SERVICE ACTION

Reference number:	SA-10-1127V2	Issued: 9 August, 2018
Subject:	Fuel filler latch	
Model(s):	Vantage 19MY	
VIN range:	Refer to the separately published list of Vehicle Identification Numbers (VINs)	
Applicable to:	All Dealers	
Distribute to:	After Sales Manager Executive Manager Service Manager Sales Manager	Warranty Staff Technician(s) Parts Staff

Figure 1

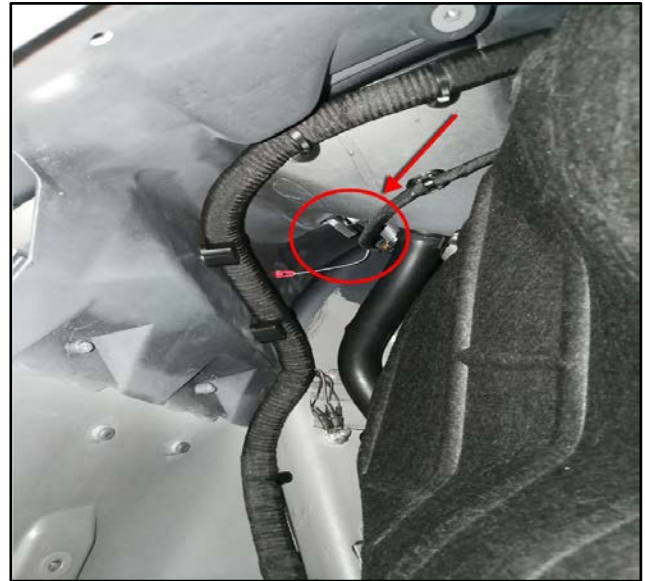
Aston Martin has found that the fuel filler latch mechanism can move out of position. If the fuel filler latch is not in the correct position the fuel filler door will not open or close correctly.

1. Remove the rear right-side wheel-arch liner (refer to Workshop Manual procedure 01.08.AK).
2. Remove the fuel filler latch from the clips that attach it to the vehicle body (refer to Figure 1).

Figure 2

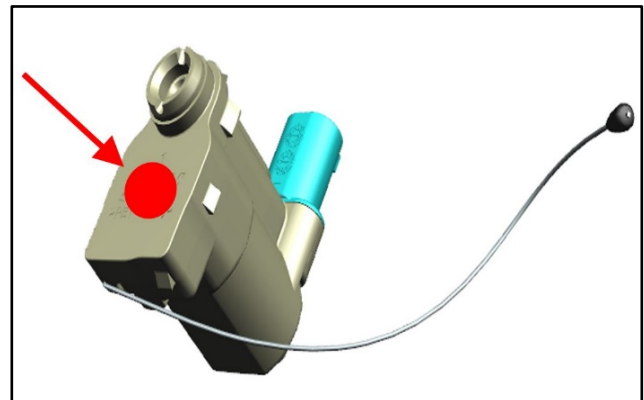
3. Apply Plexus MA300 adhesive in the location shown by the red dot (refer to Figure 2).

4. Install the fuel filler latch into the clips that attach it to the vehicle.
Note: Make sure that you hear a “click” sound as the fuel filler latch engages into position.
5. Keep the fuel filler door open for a minimum of fifteen minutes while the Plexus adhesive cures.
CAUTION: IF YOU DO NOT GIVE THE PLEXUS ADHESIVE TIME TO CURE, THE FILLER LATCH MAY NOT BE INSTALLED CORRECTLY.
6. Install the rear right-side wheel-arch liner (refer to Workshop Manual procedure 01.08.AK).
